Road & Bridge Design Publications

Monthly Update – February 2026 (reissued)

Revisions for the month of **February** are listed and displayed below and will be included in projects submitted for the **June** letting.

R-43-J

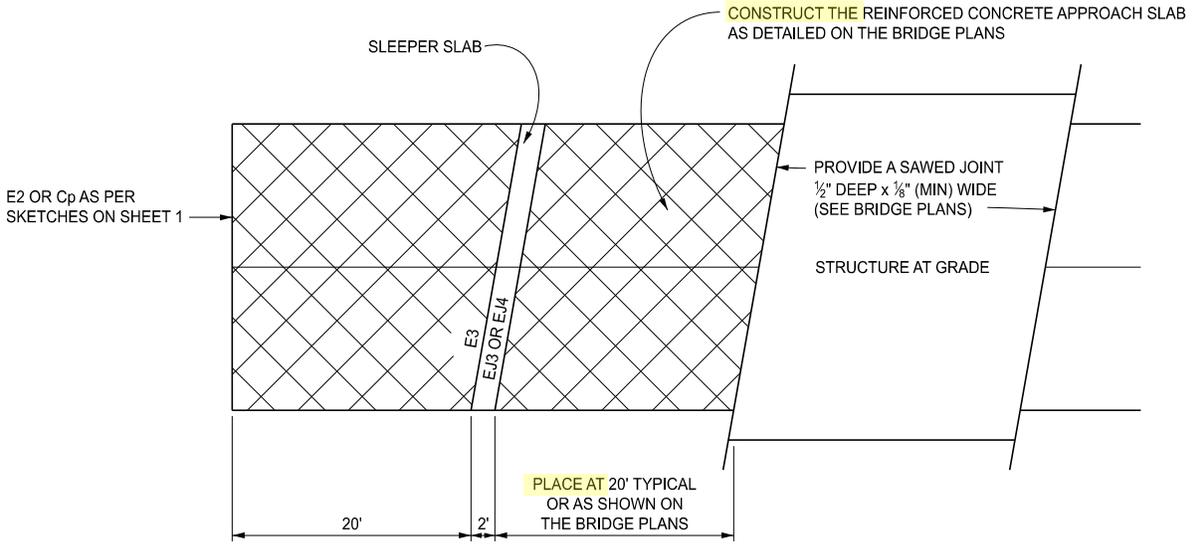
R-43-J: Location of Transverse Joints in Plain Concrete Pavement:

Converted notes and callouts to active voice.

R-55-H

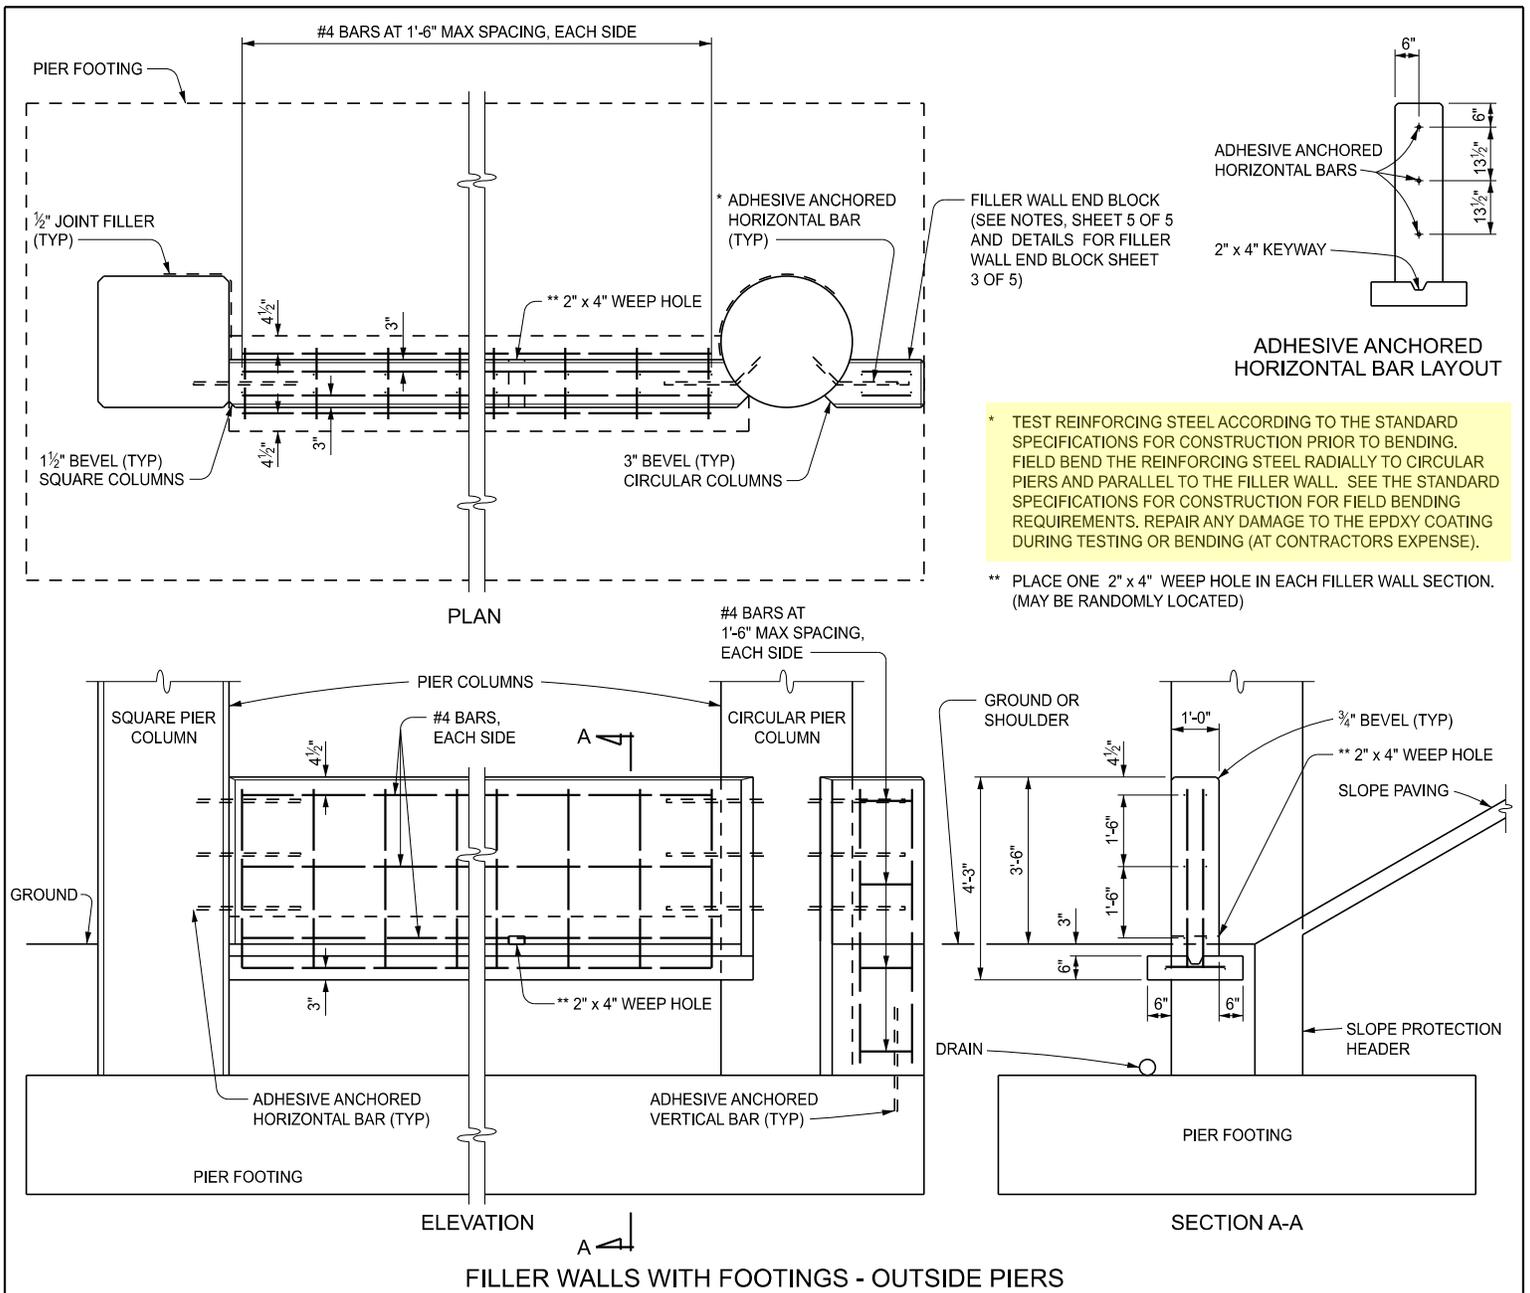
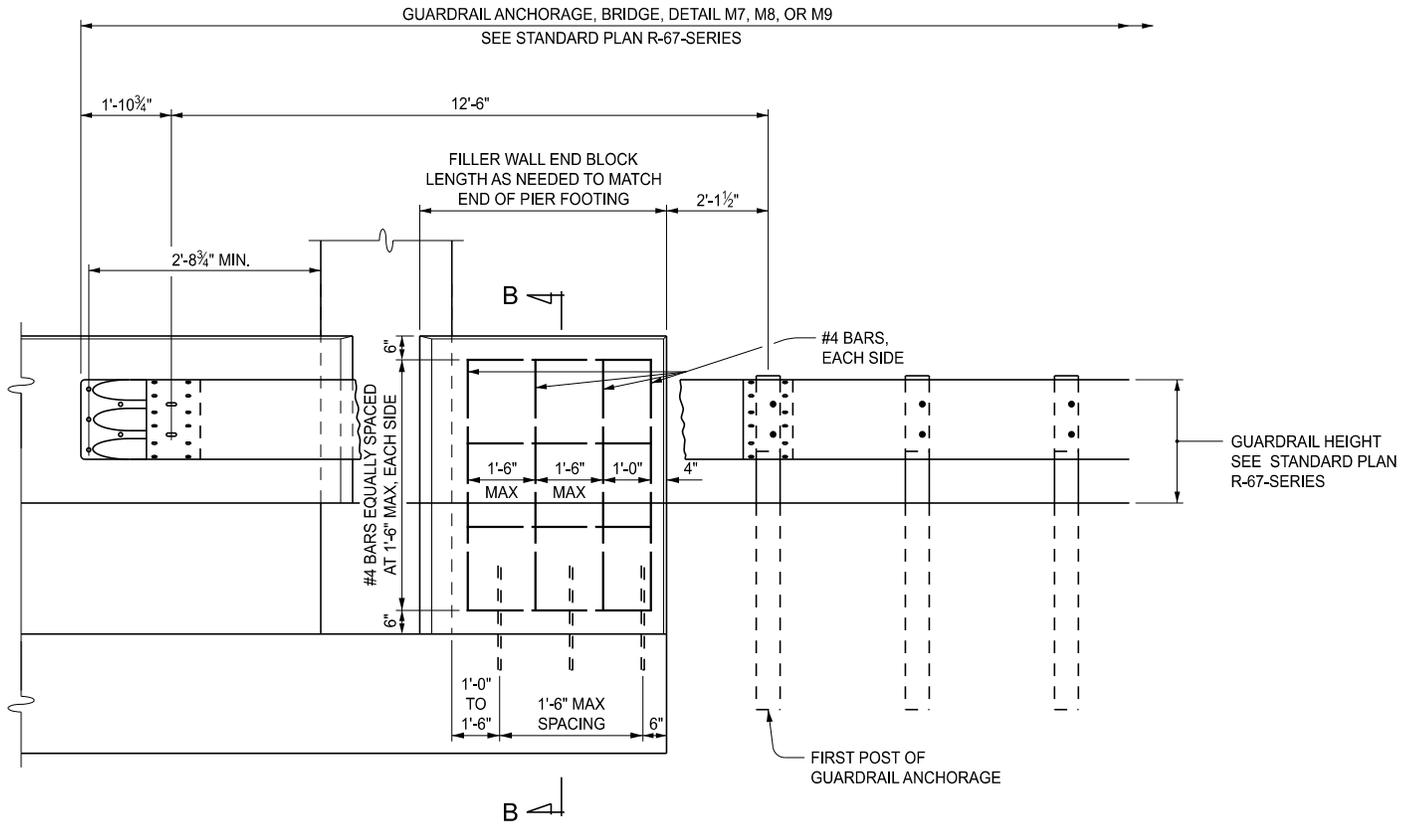
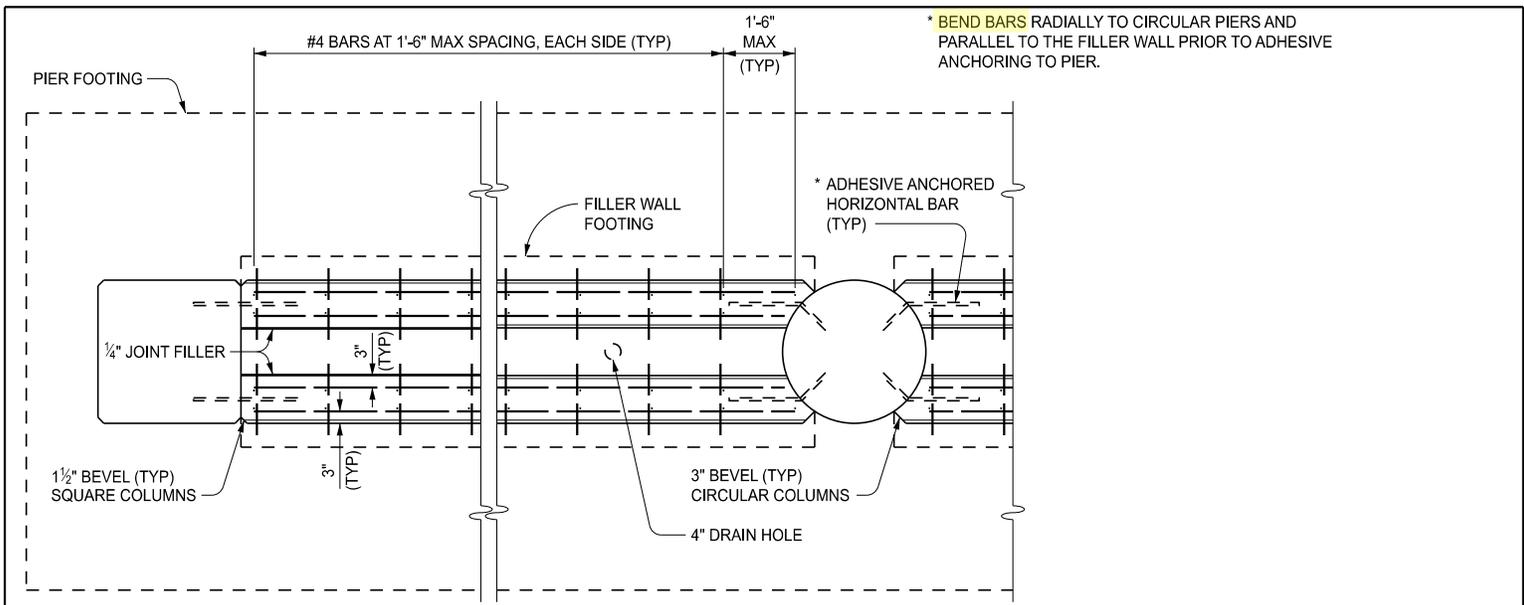
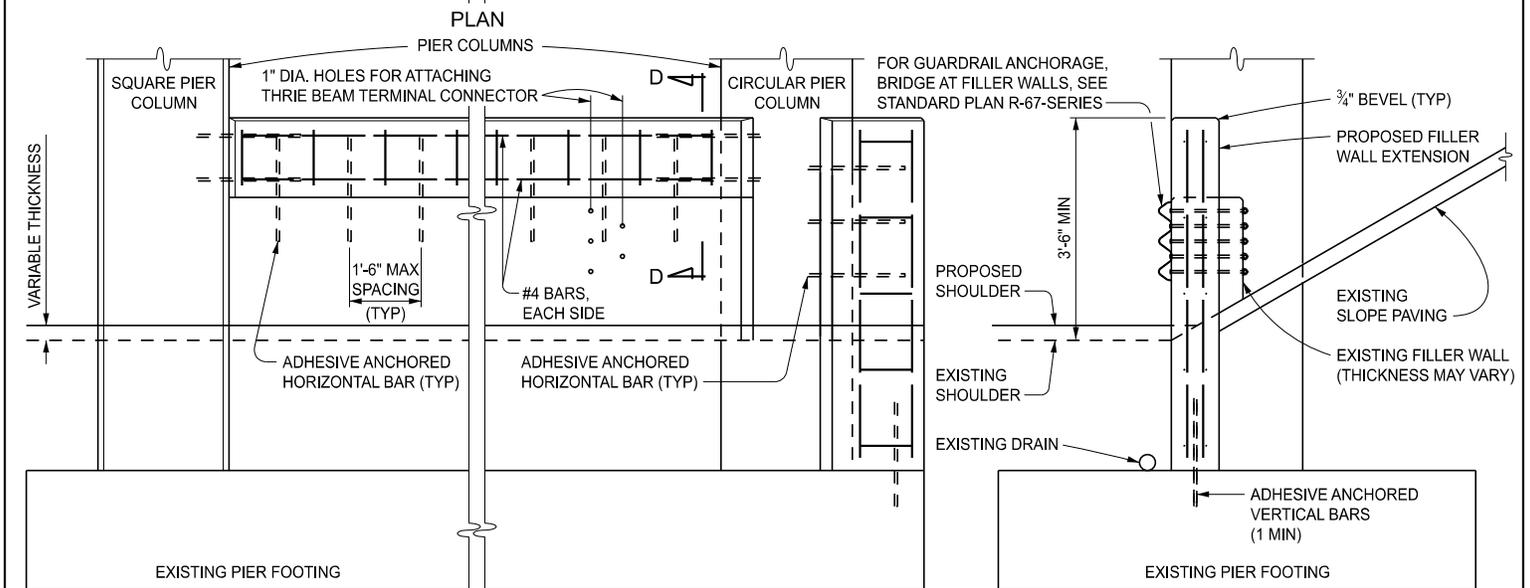
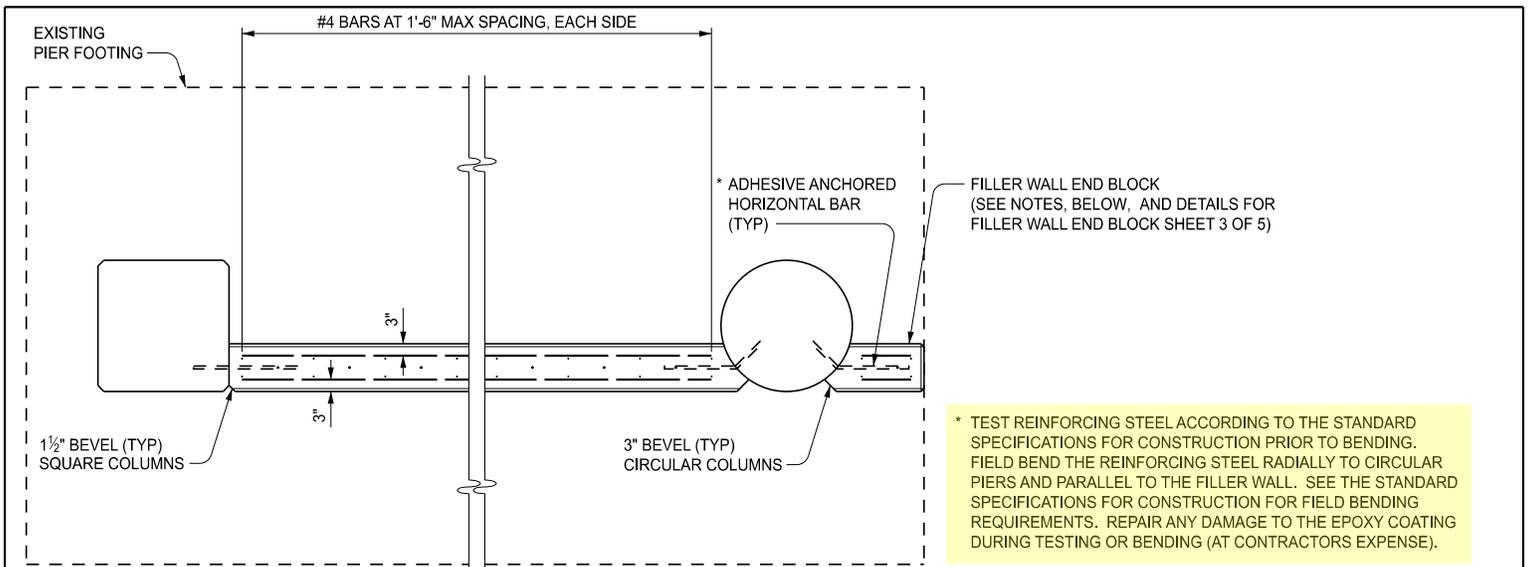
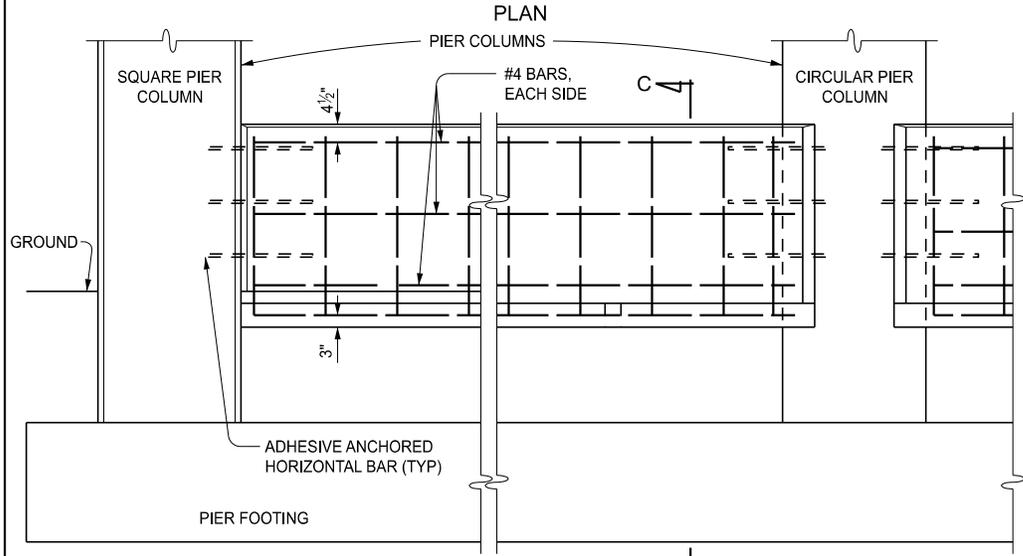
R-55-H: Filler Walls at Bridge Pier Columns:

Converted notes and callouts to active voice.

R-62-H

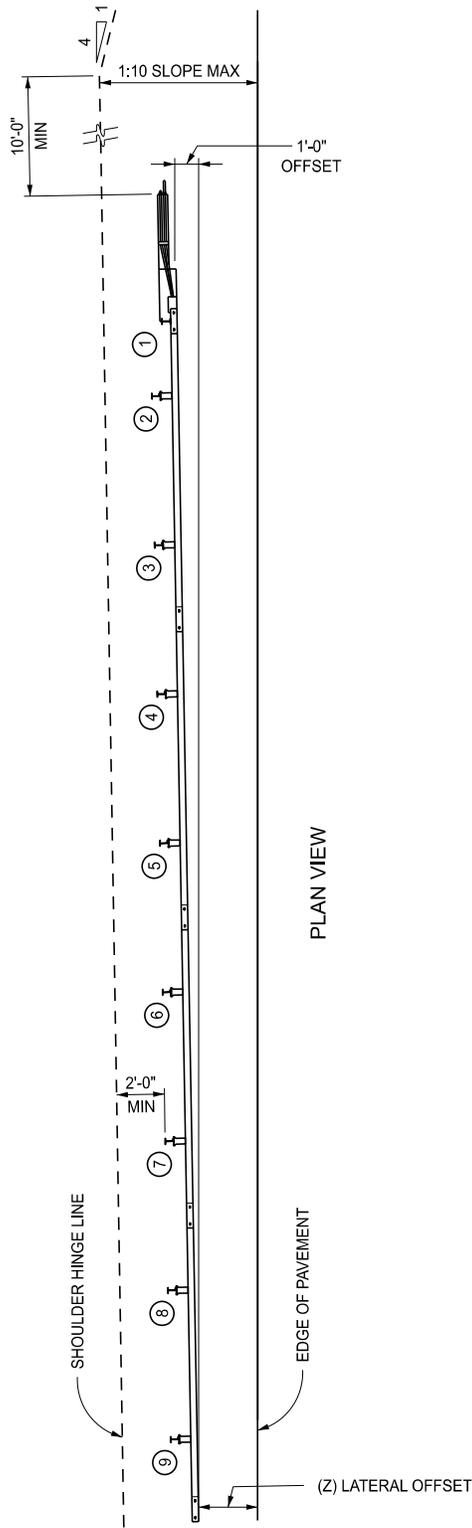
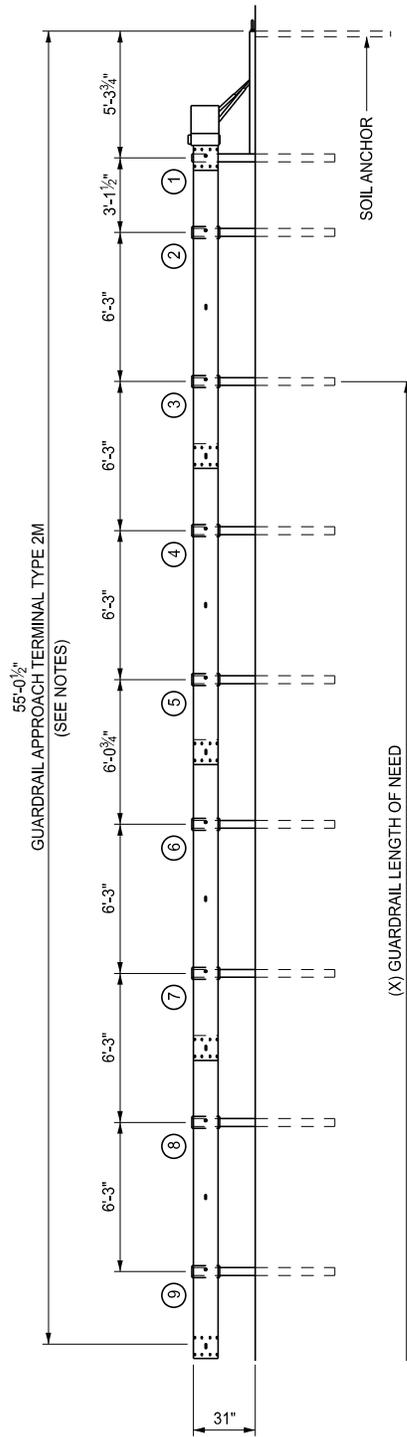
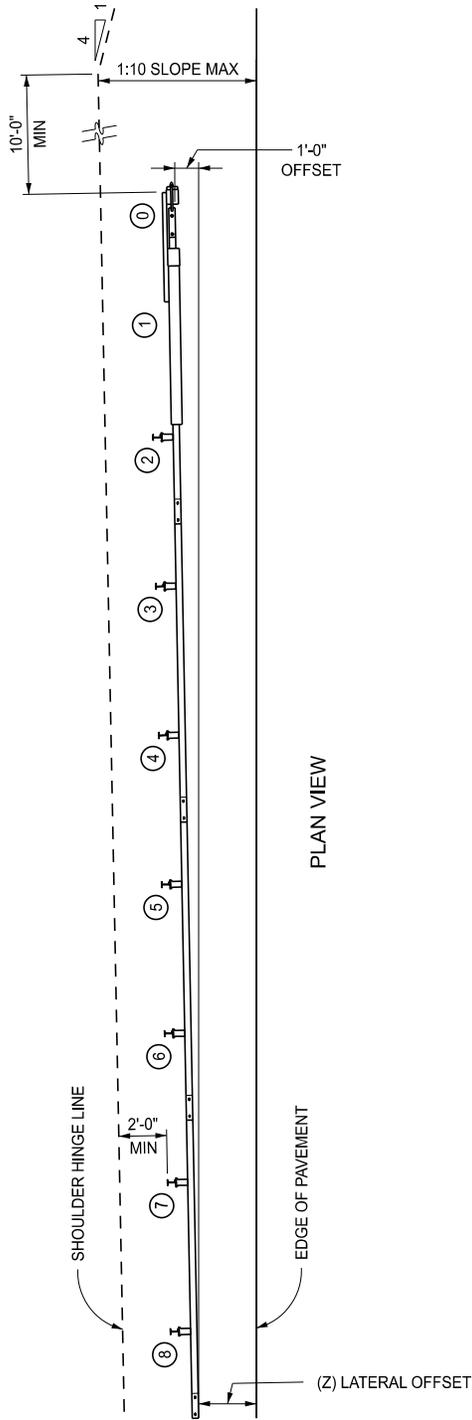
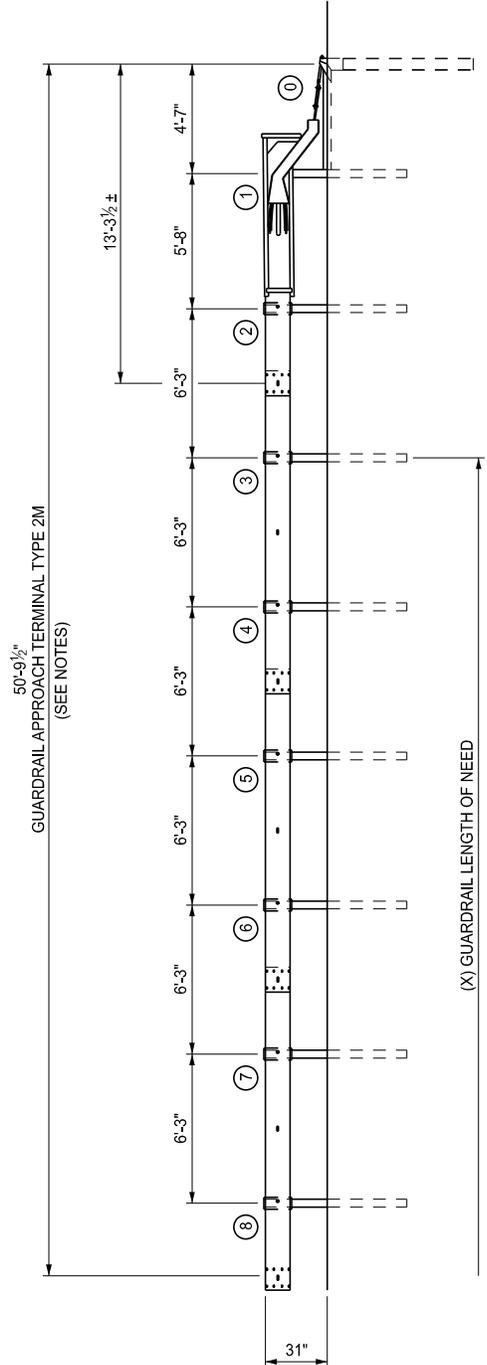
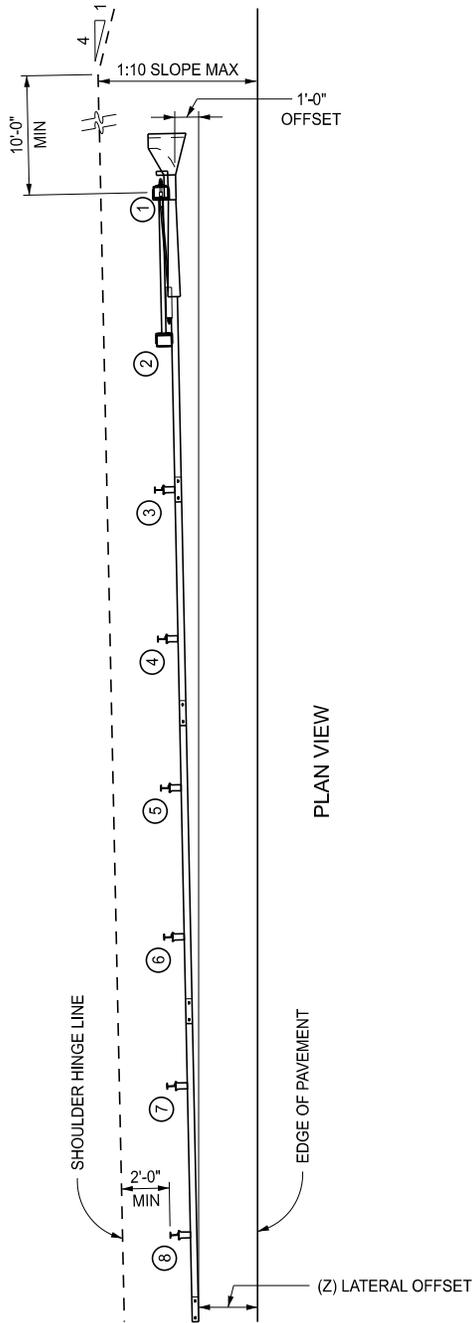
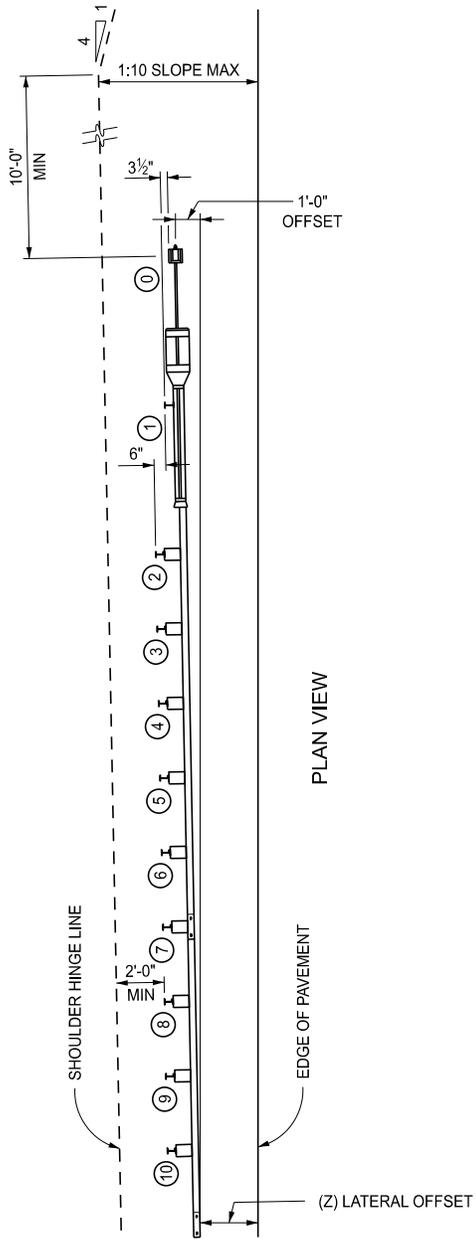
R-62-H: Guardrail Approach Terminal Type 2M:

Converted notes and callouts to active voice.
